## INDEPENDENT URBAN DESIGN ADVICE

### PROPOSED VICTORIA GARDENS EXPANSION

JULY 2022

Our Ref: 22047

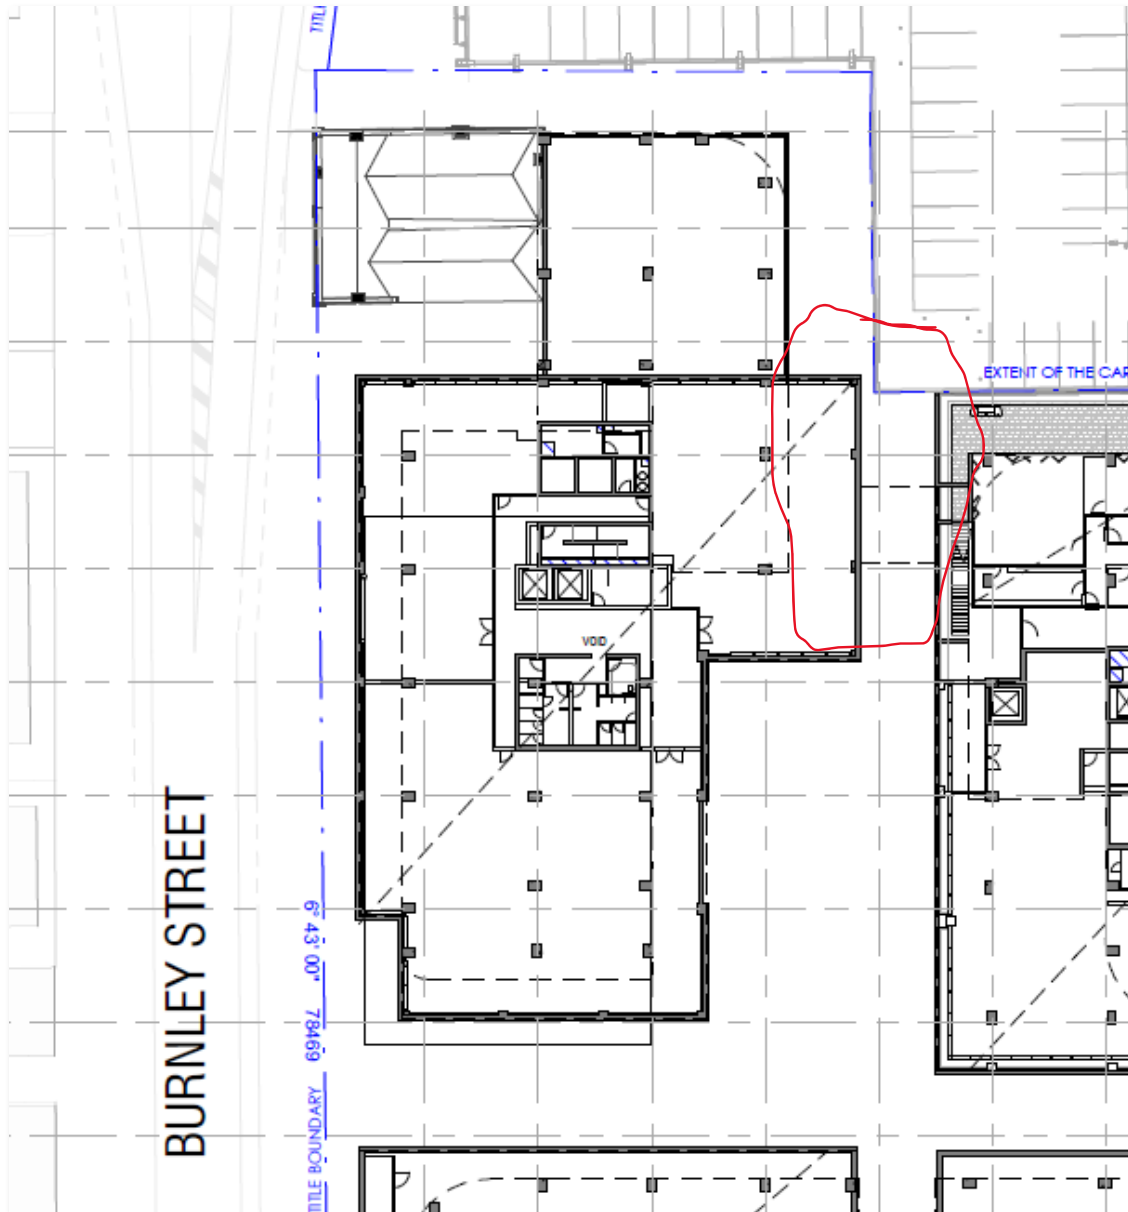
100. Additionally the development of the site should be informed by earlier feedback we have provided regarding height, shared amenity, quality of semi-private podium shared areas and the importance of interconnectivity through the precinct.

101. As noted, the provision of laneways is supported, and their general alignment is similarly supported.
102. What is not supported is the narrow dimensional characteristics, lack of clear wayfinding and overhanging of the laneway at key locations.

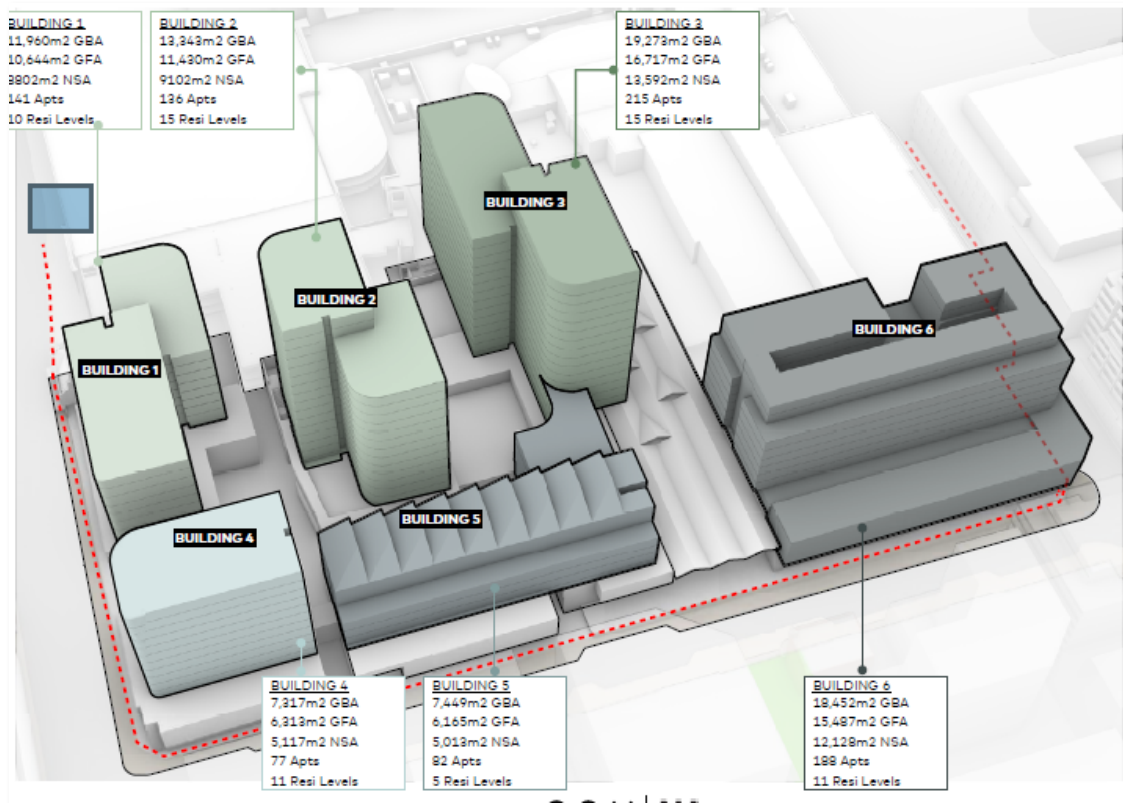
119. Based on the principles of preserving solar amenity along with the scaling of the building interfaces with Burnley Street to appropriately connect with the built form of neighbouring zones it is clear that the indicative scale of building 4 is excessive and substantial change is required.
120. It would be my recommendation that the scale of the tower is lowered to ensure that the south side of Doonside Street is protected to the kerb line at the September equinox between the hours of 10:00am and 2:00pm.

121. It is my view that the proposed urban park to the south side of Doonside Street should be protected from any additional overshadowing arising from development on the subject site between the hours of 11:00am and 2:00pm at the winter solstice.

122. I would similarly argue that the eastern footpath of David Street should be protected between the hours of 10:00am and 2:00pm at the September equinox.

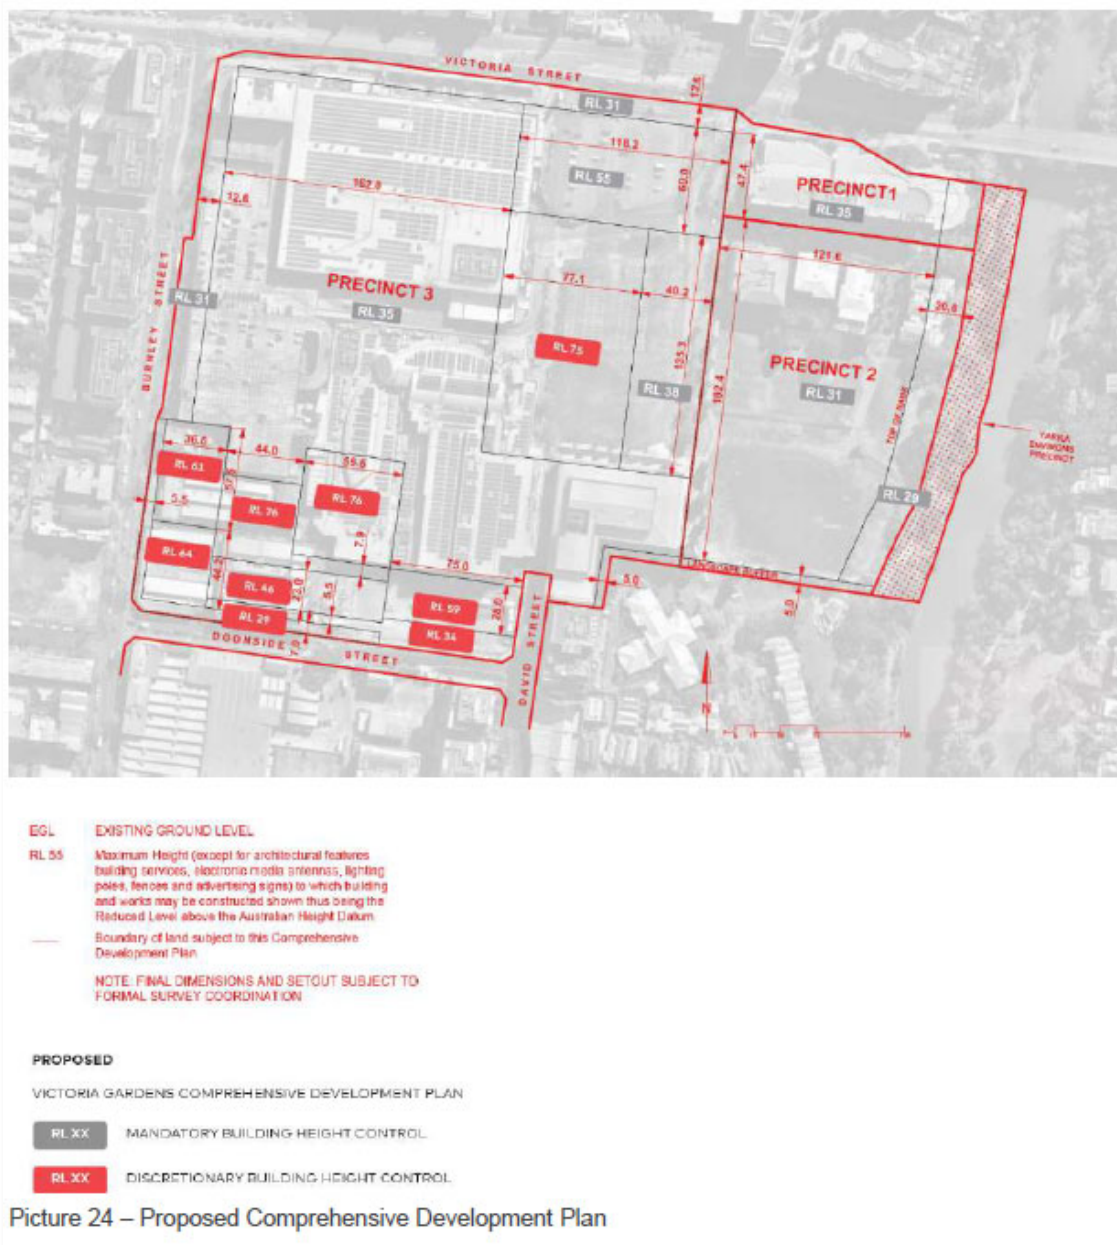
137. The inclusion of further above ground carparking is in my view a retrograde step and needs to be reviewed. It is apparent elsewhere in adjoining development that this is not necessary, and the importance of the ground plan being dedicated to both economically productive and amenity enriching activity should be self-evident. Parking above ground will only further encumber opportunities for ground level interconnectivity.
